# Access Compliance Report

## Public Rights-of-Way

### (Curb Ramps)

Intersection ID: 11170	Main Street: E_22ND_ST	Cross Street: N_DAVIDSON_ST	Location: N
ADA ID: 697B9F414B42	Ramp Type: Perp	Initial Pass/Fail: Fail	Overall Compliance: No
Severity Score: 21.25			
Codes/Mitigation Info/Possible Solution		Field Measurements/Component Compliance

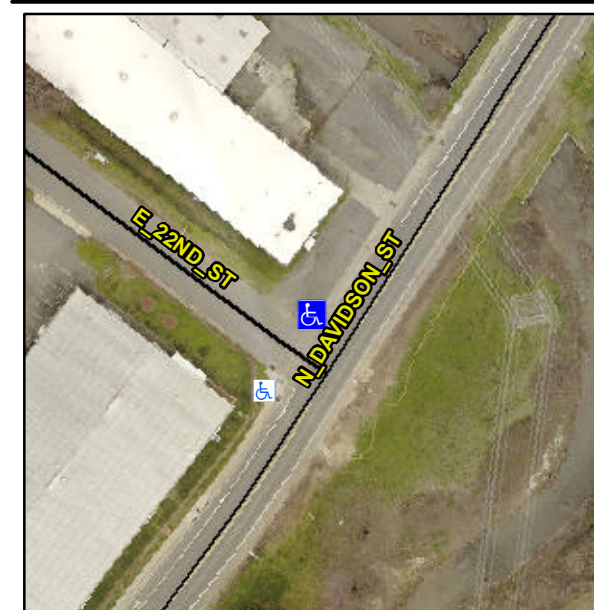
**Not Found, R304.5.1, R304.2.2**

Compliance	Description	Data	Compliance	Description	Data
N/A	Ramp Length (in)	48.0	No	Ramp Slope (%)	10.6
No	Ramp Width (in)	45.0	Yes	Ramp XSlope (%)	1.9
N/A	Flare Type LT	N/A	N/A	Flare Type RT	N/A
N/A	Flare Slope LT (%)	N/A	N/A	Flare Slope RT (%)	N/A
N/A	Flare Traversable LT?	N/A	N/A	Flare Traversable RT?	N/A
N/A	Landing Length (in)	N/A	N/A	DWS Provided?	N/A
N/A	Landing Width (in)	N/A	N/A	DWS Contrast?	N/A
N/A	Landing Slope (%)	N/A	N/A	DWS Length (in)	N/A
N/A	Landing X Slope (%)	N/A	N/A	DWS Full Width?	N/A
N/A	Landing Curb? (Y/N)	N/A	N/A	DWS Offset (in)	N/A
N/A	Shared Landing?	N/A			
N/A	Gutter Ponding?	N/A	N/A	Gutter Slope (%)	N/A
N/A	Gutter Lip Ht (in)	N/A	N/A	Gutter X Slope (%)	N/A
N/A	Painted X Walk1?	No	N/A	Painted X Walk2?	N/A
	X Walk 1 Direction	To SW		X Walk 2 Direction	N/A
N/A	X Walk 1 Width (in)	N/A	N/A	X Walk 2 Width (in)	N/A
	X Walk 1 Slope (%)	0.3		X Walk 2 Slope (%)	N/A
	X Walk 1 X Slope (%)	1.0		X Walk 2 X Slope (%)	N/A

**Remove & Replace Entire Ramp.**
